UNITED STATES PATENT AND TRADEMARK OFFICE

10/500,191

Office Action Summary	Application No. 10/500,191	Applicant(s) SANO, MASAHIRO	
	Examiner Geoffrey L. Knable	Art Unit 1791

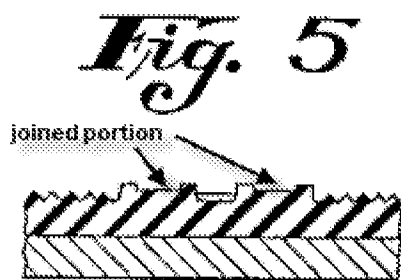
Vizina discloses a tire including a sidewall having a serrated background pattern (e.g. note various cross-sections) defining what is considered to be a decorative portion having interconnected tops and bottoms in the protruding direction protruding from the sidewall. Further, protruding portions higher than the tops of the decorative portions are provided in the pattern (esp. fig. 5) with a flat portion between adjacent protruding parts (i.e. the flat part between each of the two raised portions in fig. 5) depicted as higher than the bottoms of the decorative portion (e.g. note again esp. fig. 5). This flat portion at present reads on the claimed "joined portion" that joins two protruding portions (i.e. the two raised areas adjacent thereto in fig. 5). Note further that although this joined portion is depicted at a single protruding height, the claimed reference to "bottoms" of the joined portion does not exclude this construction as there is no requirement for other parts at a different protruding amount. Although not working drawings, the relative heights depicted in this patent are considered to anticipate claim 1, or in any event, it would have been obvious to build a tire following the relative dimensional requirements of this reference, this rendering the claimed tire obvious in view of this teaching. As to claim 3, the flat portion between the two adjacent protruding portions in fig. 5 continuously extends between the adjacent protruding portions, each of these protruding "portions" defining a character (e.g. the letter "L"). As to claims 4 and 7, Vizina is applied for the same reasons as set forth in the last office action. As to claims 9 and 11, note again that the protruding portions define a group of letters "L" (fig. 2). It

is additionally noted that even the raised protruding *portion* within each overall letter “L” in fig. 5 also defines a letter “L” and thus a group of letters.

With respect to Vizina, it is argued that the bottoms of the flat portion between the characters "L" has the same level as the bottom of the decorative portion. This argument has been carefully considered but is unpersuasive. As noted in the statement of rejection, the flat portion between the protruding portions is depicted as higher than the decorative portion and therefore reads on the claimed joined or flat portion. Note the following marked up copy of fig. 5:

Each raised area adjacent the flat joined portion defines a protruding "portion", even if they appear to define with other portions an entire outline character.
